HOMESTEAD NORTH AT STERLING RANCH FILING NO.3

STREET IMPROVEMENT PLAN

HOMESTEAD NORTH AT STERLING RANCH FILING NO.3
COUNTY OF EL PASO, STATE OF COLORADO
STORM & POND PLANS

NOTES

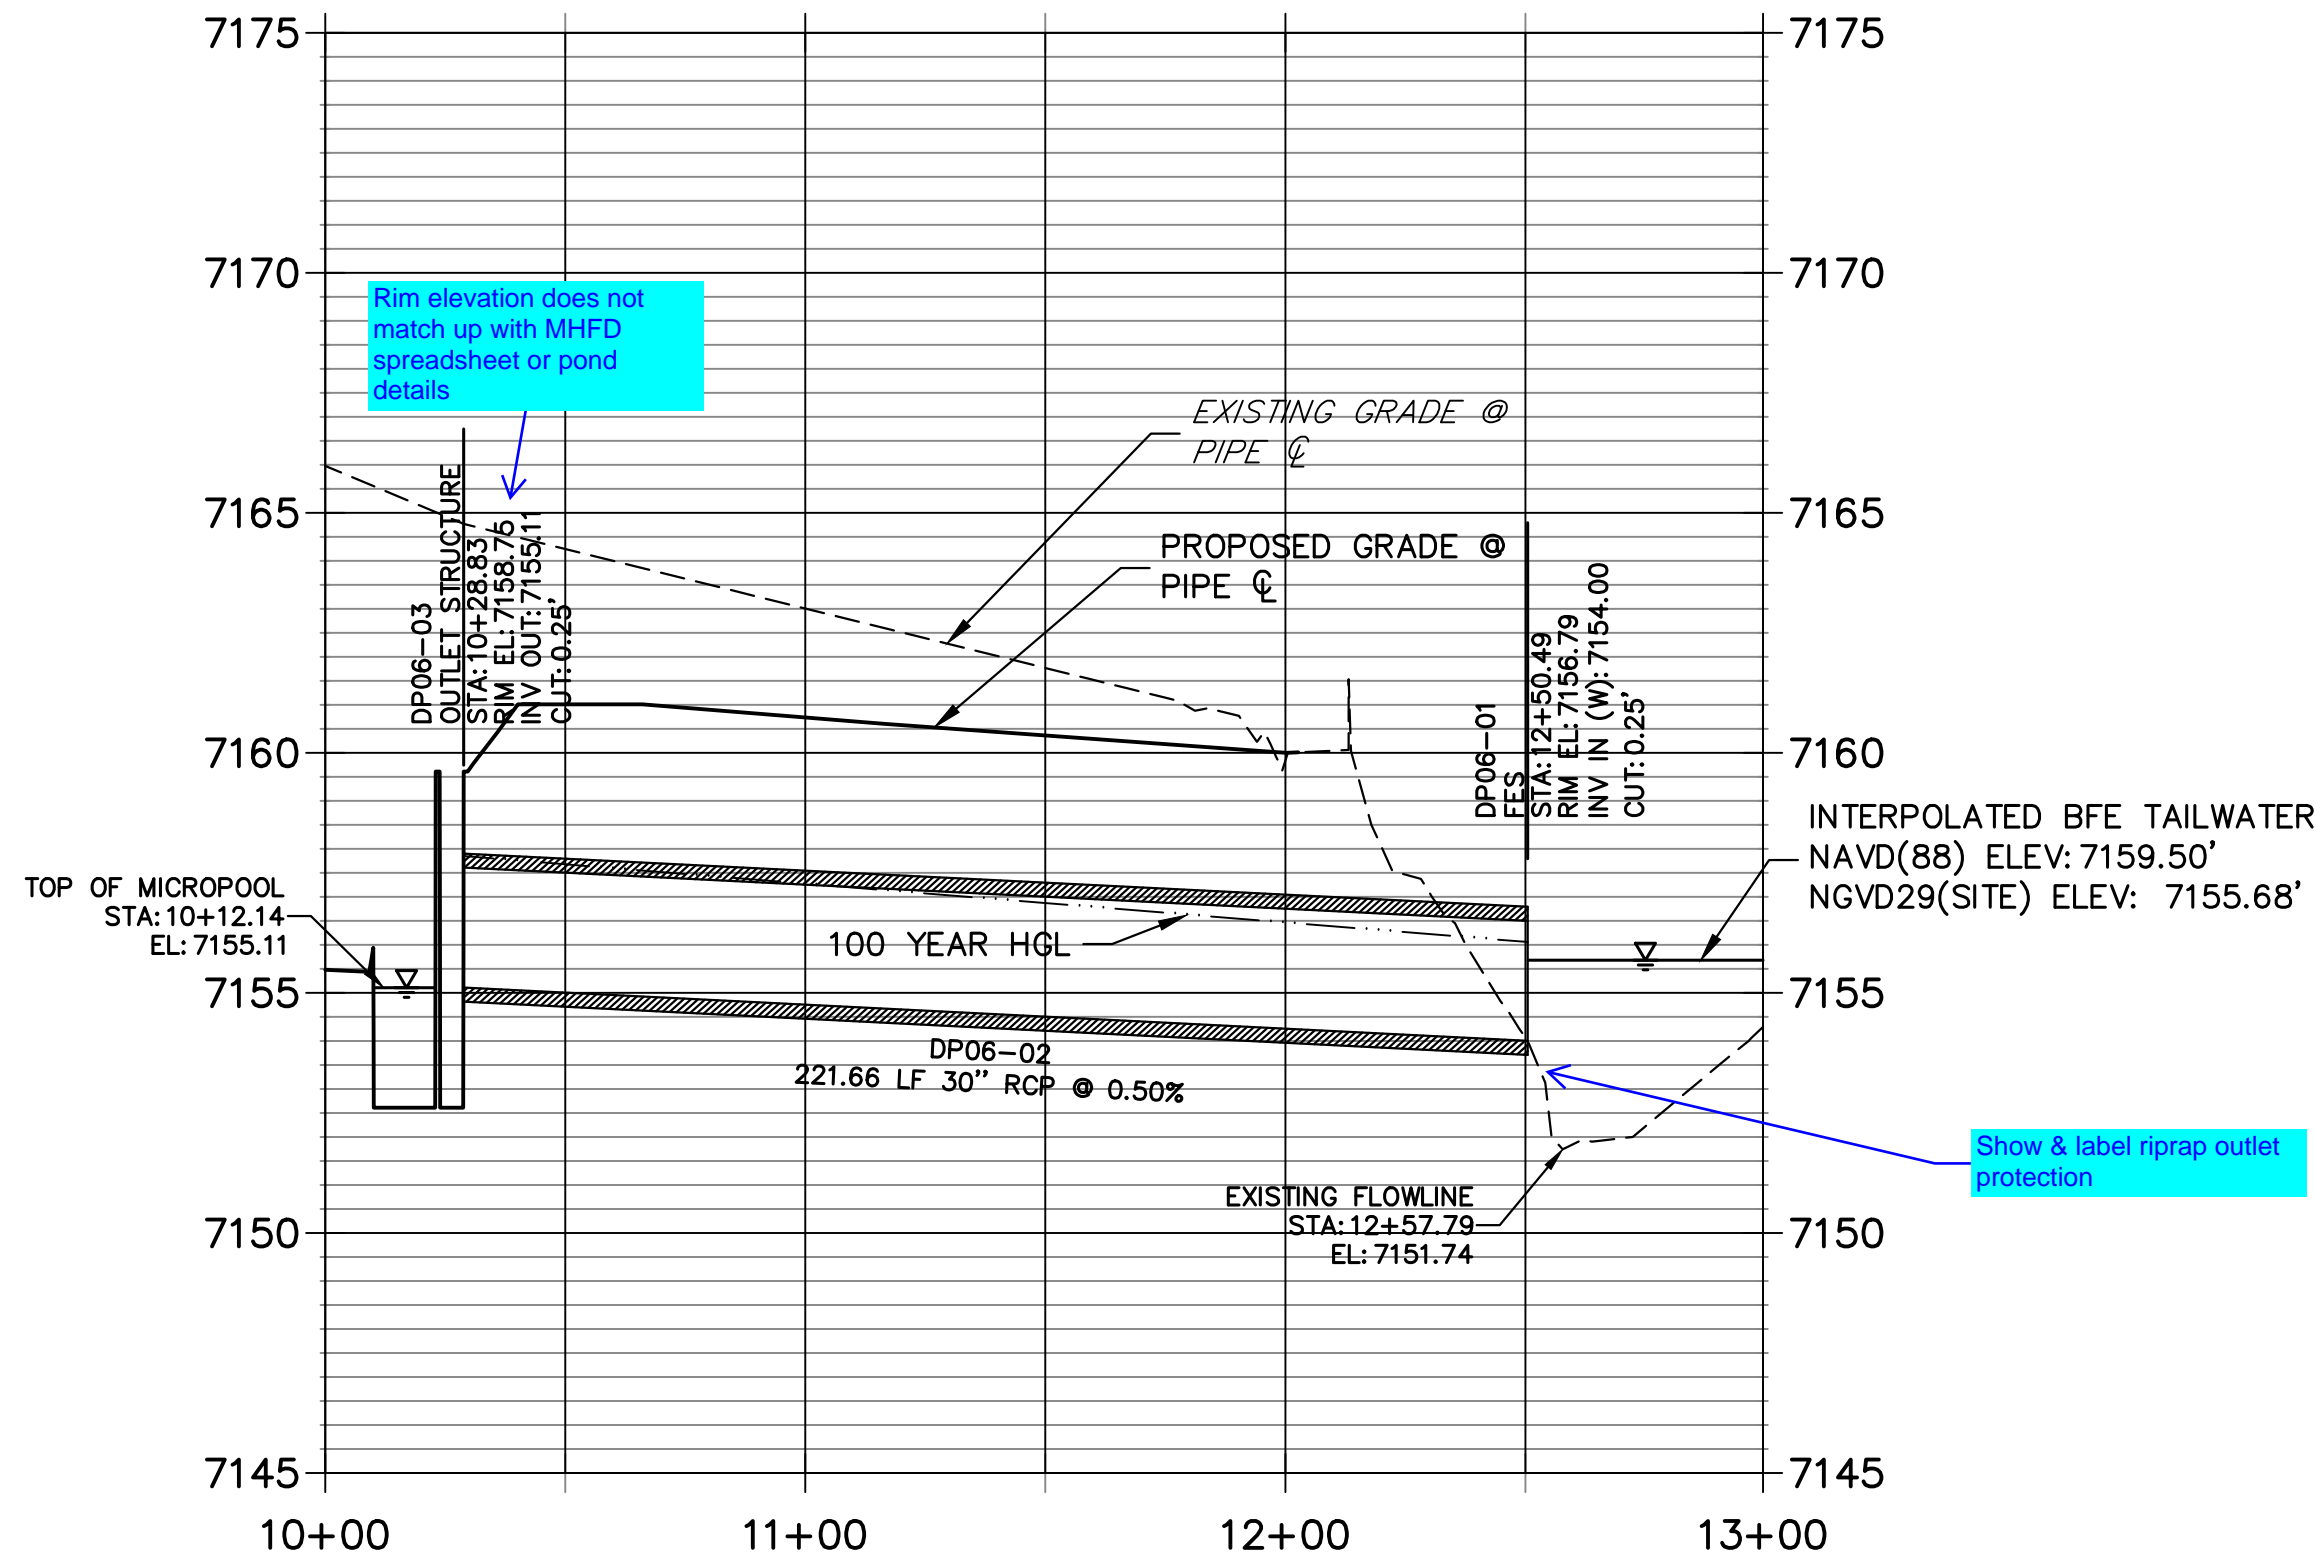
Show & label riprap outlet protection

Highlighted elevations (Storm sheets 4-6, plan & profiles) do not match with stormcad information

POND PLANS

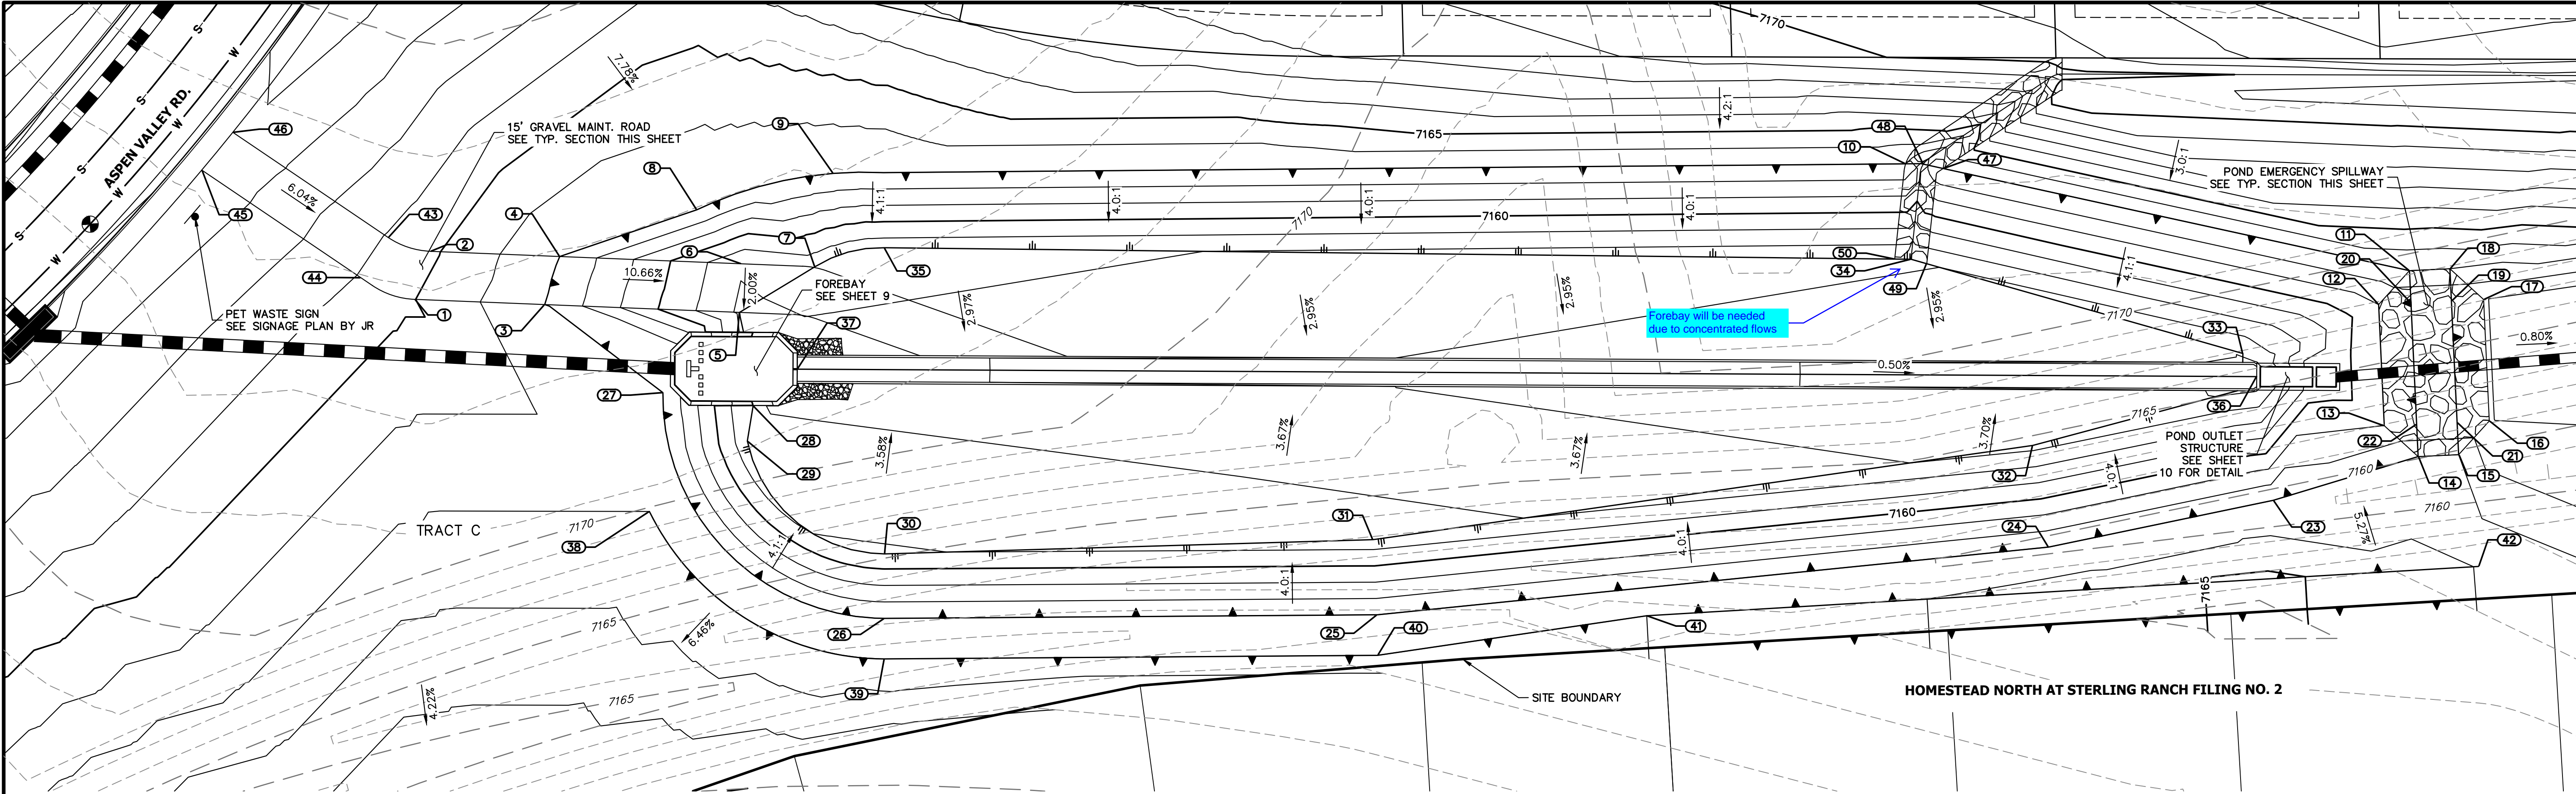
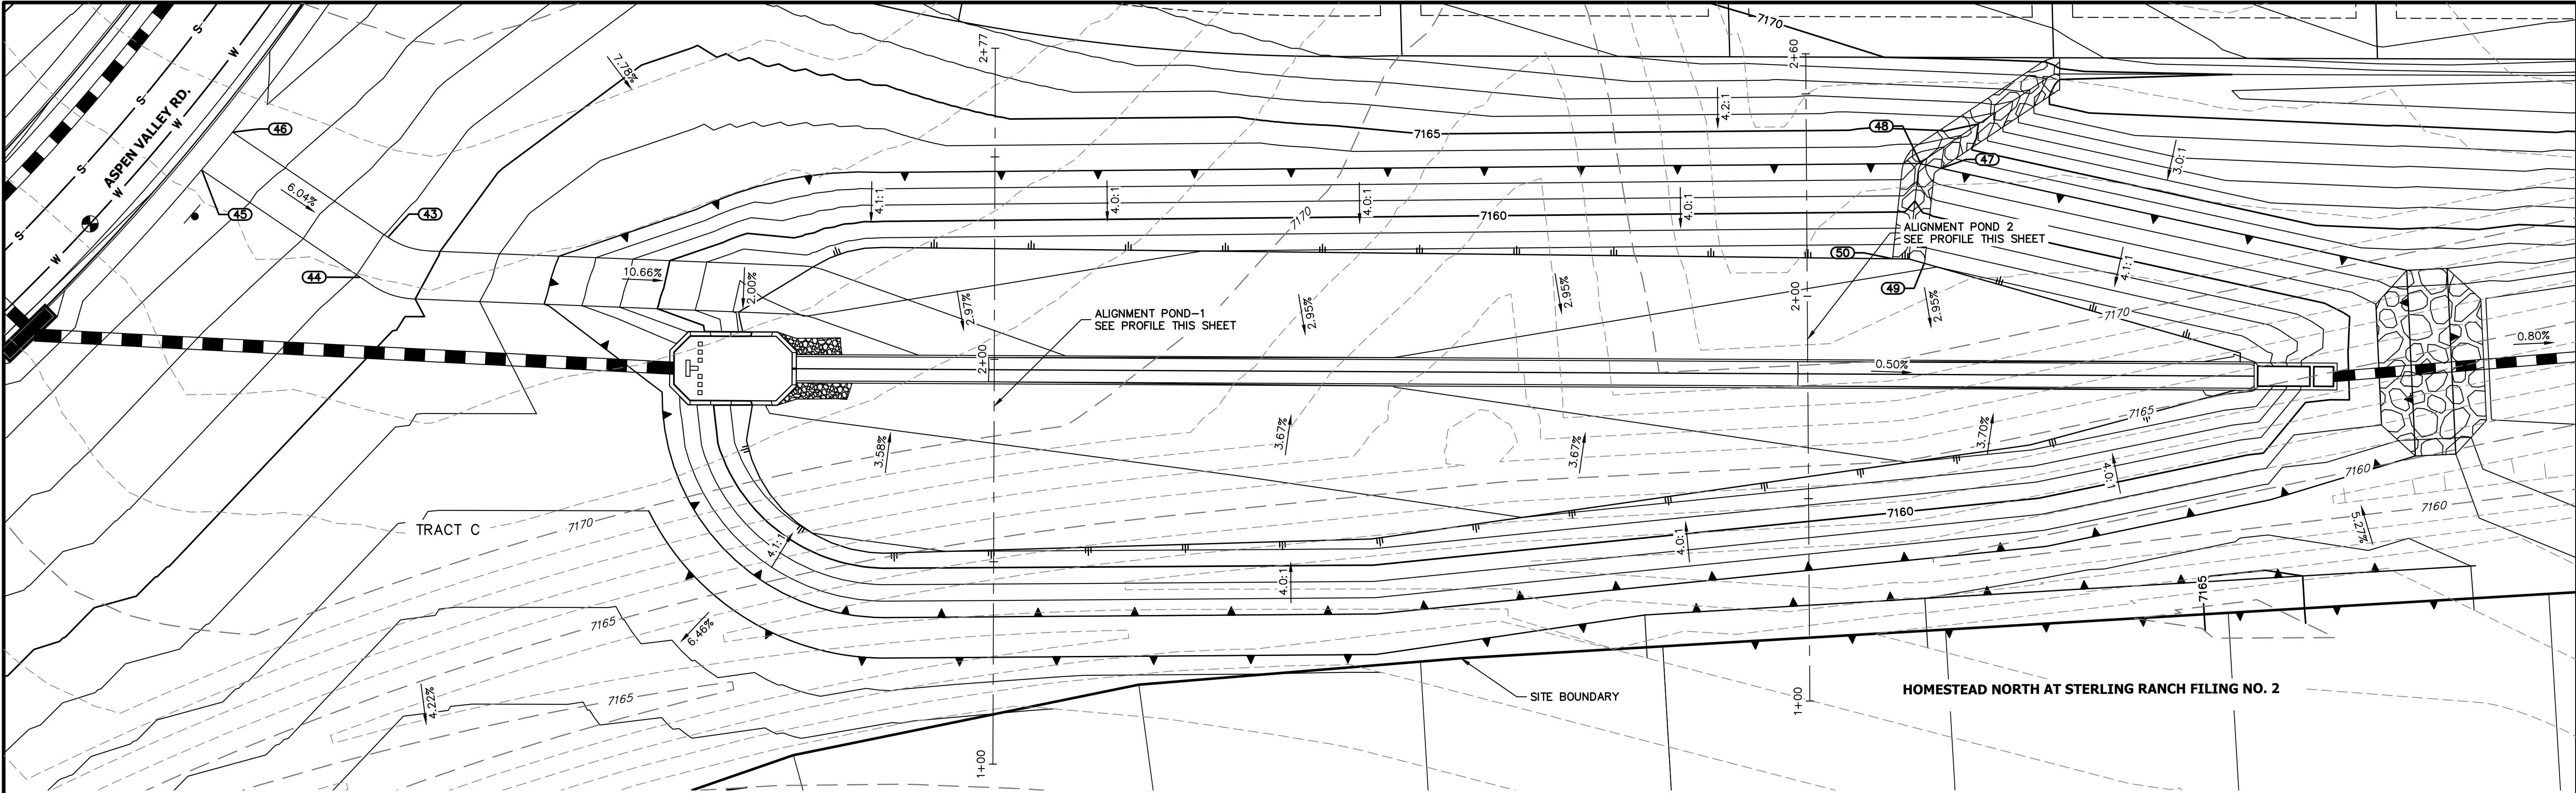
Riprap should extend to toe of slope. See detail in appendix C of drainage report

Label riprap outlet protection and provide a detail

Label rundown and provide detail
